Parker Flats Phase II MRA, Former Fort Ord

FIELD VARIANCE FORM

SUBJECT:
 Portable Field Screen Implementation for High Density Metallic Debris in Soil

CORRECTIVE ACTION REPORT

Figure 1

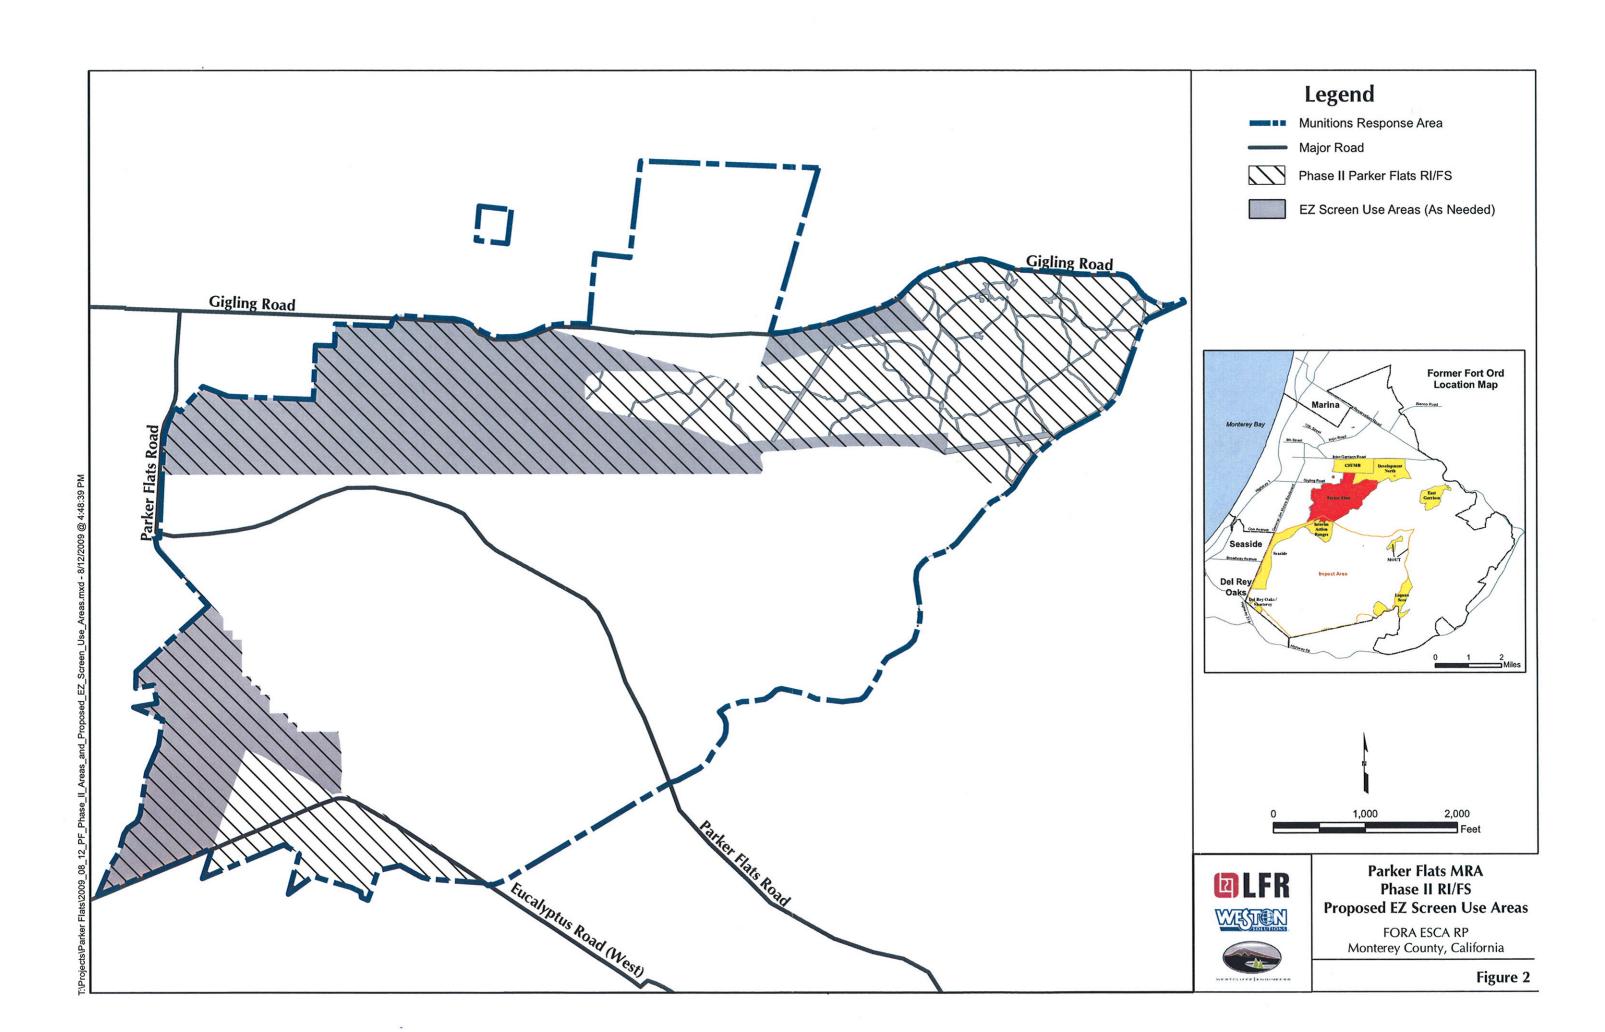
During the digital geophysical mapping (DGM) anomaly investigation in the Parker Flats Munitions Response Area (MRA) Phase II, selected anomaly targets are investigated in accordance with the above referenced work plan; however, isolated areas are found to contain a high density of small metallic cultural debris or ammunition links, which are not feasible to manually remove from the soil. Each of these areas will have large amplitude response anomaly contacts investigated prior to the use of the screen on the soil containing high density metallic debris. The use of the screen will allow the Environmental Services Cooperative Agreement Remediation Program (ESCA RP) Team to confirm and catalog the metallic debris removed from the soil in these areas. The ESCA RP Team will modify field activities to incorporate the use of a portable mechanical screen in accordance with the recommended approach described below.

A portable mechanical screen will be mobilized to the field as needed (Figure 1). An unexploded ordnance (UXO) team, consisting of a minimum of two UXO Technicians will use the portable 3/8-in. mesh screen to inspect the soil. The stockpiled soil containing the small metallic debris will be removed from the dig location The soil will be visually inspected and any large metallic debris or oversized material will be removed. If the soil is found to contain a considerable amount of small metallic debris or ammunition links, it will be gently loaded into the portable screen using a backhoe or similar equipment. The metallic debris captured by the portable screen will be inspected, cataloged, and weighed per area for reporting purposes, then disposed off-site in accordance with the above-referenced work plan. The soil and any debris less than 3/8-in. that passes through the portable screen will be returned to the excavation following the completion of quality control procedures (QC-1). In addition, to initially evaluate the effectiveness of this operation, the first 15 high density areas undergoing this procedure will undergo a QC-2 survey as detailed in the above-referenced work plan. The objective of the QC-2 survey is to demonstrate that this revised approach to high density areas is effective or provides an opportunity to improve the efficiency of the anomaly investigation process. Oversized (greater than 3/8 of an inch) non-metallic debris (e.g., wood or rock chips) will be sorted from the metallic debris, inspected, and stockpiled on plastic with the material that passes through the screen (<3/8-in.).

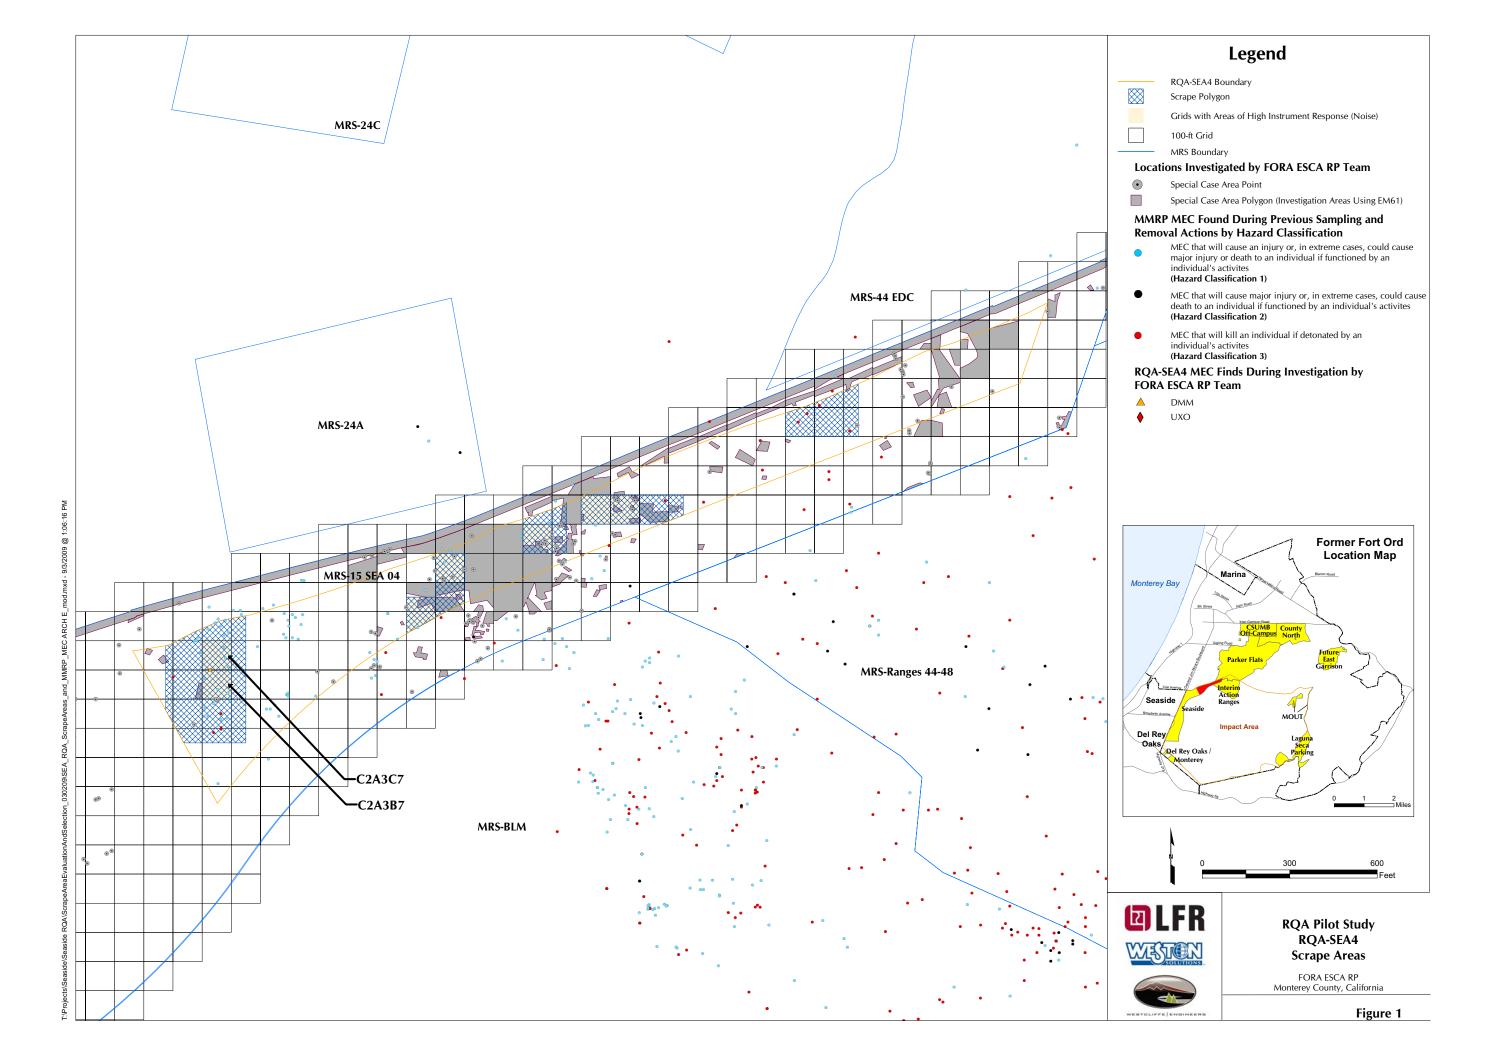
During the post-scrape anomaly investigation in grids C2A3B7 and C2A3C7 of the Seaside Residential Quality Assurance (RQA) Pilot Study area (RQA-SEA.4; Figure 1), eight munitions debris (MD) items (seven MK II Practice Hand Grenades and one MK I Training Hand Grenade) were found during target anomaly excavations, as indicated in the program memorandum to the Fort Ord Reuse Authority (FORA) provided in Attachment A. Seven of the eight MD items were selected as targets for excavation during the baseline digital geophysical mapping (DGM) survey; however, the dig teams and the QC-1 operator were unable to locate the MD items in the field using established procedures and equipment. Data from the post-scrape anomaly investigation indicated that the MD items were buried from 12 to 21 inches below ground surface (bgs) prior to scrape activities. The inability of the dig teams and the QC-1 operator to reacquire and successfully remove these MD items during the baseline DGM survey anomaly investigation caused the Environmental Services Cooperative Agreement Remediation Program (ESCA RP) Team to analyze established procedures and detection equipment for possible corrective actions.

The first step in the analysis was to evaluate the effectiveness of the QC-1 instrument (i.e., the EM61-MK2 cart) in detecting grenades at depth. For the analysis, the practice grenades excavated during the post-scrape anomaly investigation were suspended above the EM61-MK2 coils in the least favorable orientation (i.e., grenade lying on its side with long axis parallel to long axis of the coil). The EM61-MK2 cart readings were recorded for each practice grenade at different heights. Table 1 shows the results of the analysis. In accordance with the QC-1 process established in the above-referenced work plan, the operator was using the EM61-MK2 cart in manual mode by observing Channel 2 readings. Table 1 shows that at 12 inches, the millivolt (mV) responses for the practice grenades are at the background noise threshold for detection in manual mode (5 to 6 mV). At 18 inches, the mV responses for the practice grenades are in the background noise (2 to 3 mV) and, therefore, are not detectable.

1. Areas where grenade-related MD items were found during the post-scrape anomaly investigation (within grids C2A3B7 and C2A3C7) underwent a confirmation DGM survey using the EM61-MK2 towed array sled to confirm that anomaly targets were investigated and resolved.
